STAFF REPORT

December 4, 2018

Case #18-53: SITE PLAN REVIEW
Case #18-54: NEW GROUND SIGN SITE PLAN
2904 Acushnet Avenue,
2914 Acushnet Avenue,
ES Acushnet Avenue
Map: 130D Lots: 117, 247, 248, 447

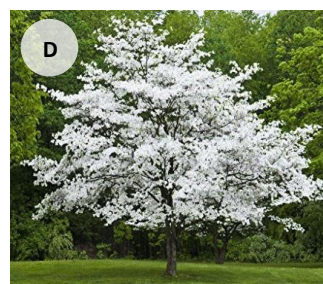
Pavement markings shown on plans include directional arrows at the two driveway entrances and for the by-pass lane around the car wash. The only other pavement markings shown are striped parking spaces. It is unclear if there is a planned circulation pattern for the proposed services and pumps as no striping is shown on plans. Further, staff notes additional pavement markings may be necessary to direct vehicles near the car wash. The board may wish to have the applicant revise the plans to include a more detailed pavement markings plan. Staff also expresses concern for potential vehicular conflicts from the car wash by-pass lane and the northern entrance.

- Bicycle racks be installed on site [*in location specified by board*];
 - Pavement marking plan to be updated for site circulation;
 - Information about the car wash water collection and treatment system be submitted;

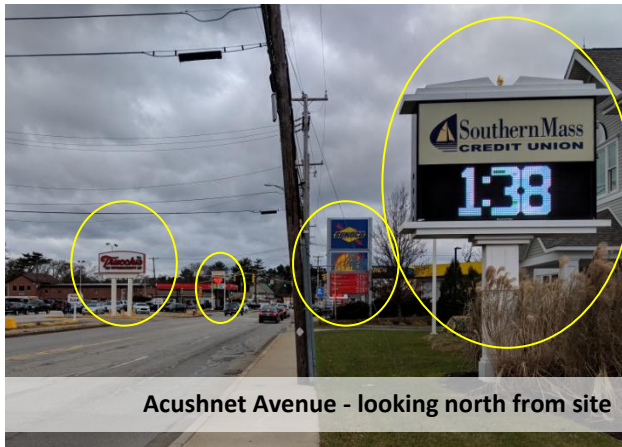
A **pylon sign** is proposed along the site frontage near the gas service island. The overall sign area is 114.77 SF, with an overall height of 25', 10'3" height from the ground to the base of the sign, width of 10'1.5", and 1' in depth. The sign as proposed includes an internally illuminated cabinet on the top, with an LED price cabinet in the middle, and an Electronic Message Center below. The base of the sign will be surrounded by a raised planter bed (1'-6"H x 6'W x 16'L). The internally illuminated sign face as proposed would be white with blue and green lettering. The sign wording is to include "Cumberland Farms" "SmartPay Member" "Regular" "Diesel" and various electronic messages.

A **second pylon sign** is proposed along the frontage near the south driveway entrance. The overall sign area is 62.98 SF, with an overall height of 20', 12'3" height from the ground to the base of the sign, width of 8'1.5", and 1' depth. The sign as proposed includes an internally illuminated cabinet on top and an Electronic Message Center below.

As noted previously, both pylon signs exceed dimensional requirements and the electronic message center is a prohibited sign type under zoning ordinance, therefore the proposed signage requires a **Variance** and **Administrative Appeal** from the Zoning Board of Appeals.
